Access Compliance Report

Public Rights-of-Way

Intersection ID: 10035658	Main Street: RED_OAK_BV	Cross Street: N/A	Location: SW
ADA ID: 2CB7569D0800	Ramp Type: MedianPerp	Initial Pass/Fail: Pass	Overall Compliance: No
Codes/Mitigation Info/Possible Solution		Field Measurements/Component Compliance

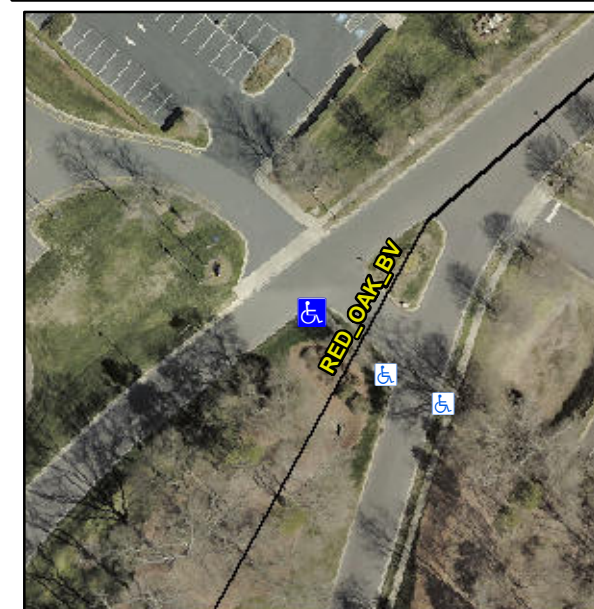
R304.2.1, R304.2.2-Perp, R304.3.2-Para, R304.5.3

Compliance	Description	Data	Compliance	Description	Data
N/A	Ramp Length (in)	52.0	Yes	Ramp Slope (%)	6.0
Yes	Ramp Width (in)	48.0	Yes	Ramp XSlope (%)	2.3
N/A	Flare Type LT	Sloped	N/A	Flare Type RT	N/A
N/A	Flare Slope LT (%)	7.0	N/A	Flare Slope RT (%)	1.2
N/A	Flare Traversable LT?	Yes	N/A	Flare Traversable RT?	No
No	Landing Length (in)	N/A	Yes	DWS Provided?	Yes
No	Landing Width (in)	N/A	Yes	DWS Contrast?	Yes
No	Landing Slope (%)	N/A	Yes	DWS Length (in)	24.0
No	Landing X Slope (%)	N/A	Yes	DWS Full Width?	Yes
N/A	Landing Curb? (Y/N)	N/A	Yes	DWS Offset (in)	0.0
N/A	Shared Landing?	No			
Yes	Gutter Ponding?	No	Yes	Gutter Slope (%)	1.6
Yes	Gutter Lip Ht (in)	0.0	No	Gutter X Slope (%)	4.0
N/A	Painted X Walk1?	No	N/A	Painted X Walk2?	N/A
	X Walk 1 Direction	To N		X Walk 2 Direction	N/A
N/A	X Walk 1 Width (in)	N/A	N/A	X Walk 2 Width (in)	N/A
	X Walk 1 Slope (%)	3.1		X Walk 2 Slope (%)	N/A
	X Walk 1 X Slope (%)	2.8		X Walk 2 X Slope (%)	N/A

Install Landing. Remove & Replace Gutter.
